Georges River Local Planning Panel

Thursday, 15 February 2024

REPORTS AND LPP DELIBERATIONS**REPORT TO GEORGES RIVER LOCAL PLANNING PANEL MEETING OF THURSDAY, 15 FEBRUARY 2024****LPP001-24 46A RUSSELL STREET OATLEY****LPP001-24**

LPP Report No	LPP001-24	Development Application No	DA2023/0115
Site Address & Ward Locality	46A Russell Street Oatley Blakehurst Ward		
Proposed Development	Alterations and additions to a dwelling house		
Owners	Stuart Palmer		
Applicant	Stuart Palmer		
Planner/Architect	Mark Phillips		
Date Of Lodgement	2/05/2023		
Submissions	One (1) submission was received		
Cost of Works	\$447,317.00		
Local Planning Panel Criteria	The application is referred to the Georges River Local Planning Panel for determination as the proposed works result in a more than 10% variation to Clause 4.3 relating to height of buildings and Clause 6.12 relating to Landscaped areas in certain residential and conservation zones		
List of all relevant s.4.15 matters (formerly s79C(1)(a))	State Environmental Planning Policy (Biodiversity and Conservation) 2021, State Environmental Planning Policy (Resilience and Hazards) 2021, State Environmental Planning Policy (Transport and Infrastru

Figure 9: Floor Plan highlighting extent of height of building development standard variation

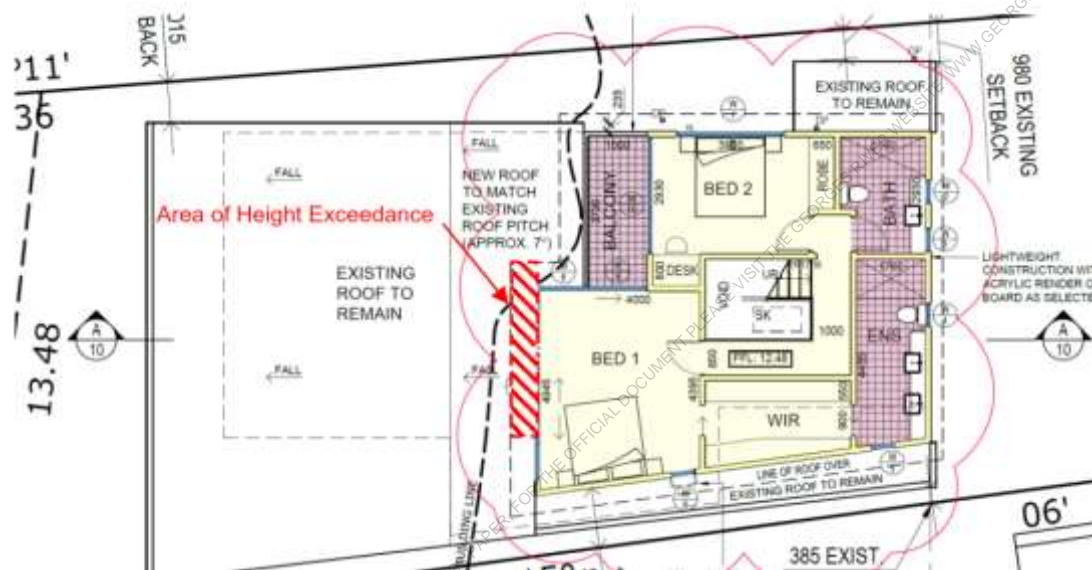
36. The proposed development fails to comply with the development standard for height. Clause 4.3(2) of GRLEP 2021 stipulates a maximum height limit of 9m for this site.
37. The proposed height is 10.11m, resulting in a 12.3% variation. The height breach arises from the proposed first-floor roof eave. It is important to note that the building is within the height limit please refer to figures 9 and 10.
38. The applicant has lodged a written request in accordance with the requirements of Clause 4.6 of GRLEP 2021. Any variation to a statutory control can only be considered under Clause 4.6 – Exceptions to Development Standards of the GRLEP.
39. The extent of the variation is shown in the figures below.

Figure 11: Site Plan illustrating works below FBL.

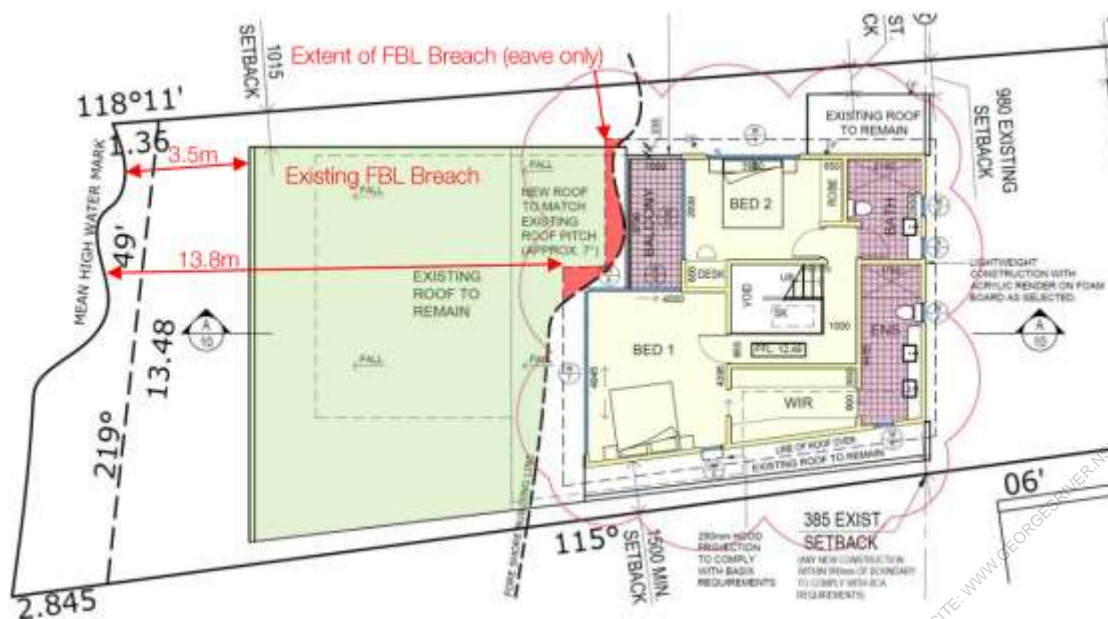
72. The development application seeks consent for the construction a portion of the first-floor eave 1.3m below the FBL, resulting in a 8% variance.
73. The extent of the variation is shown in figure 11.

74. It is noted that both adjoining waterfront neighbouring dwellings to the north and south are compliant and wholly located behind the FBL while the existing dwelling is mostly located forward of the FBL.
75. Clause 4.6(3) of GRLEP 2021 requires development consent not be granted for development that contravenes a development standard unless the consent authority has considered a written request from the Applicant that seeks to justify the contravention of the development standard by demonstrating:
- that compliance with the development standard is unreasonable or unnecessary in the circumstances of the case, and*
 - that there are sufficient environmental planning grounds to justify contravening the development standard.*
76. To support the non-compliance, the Applicant has provided a request for a variation to Clause 6.4 in accordance with Clause 4.6 of GRLEP 2021.
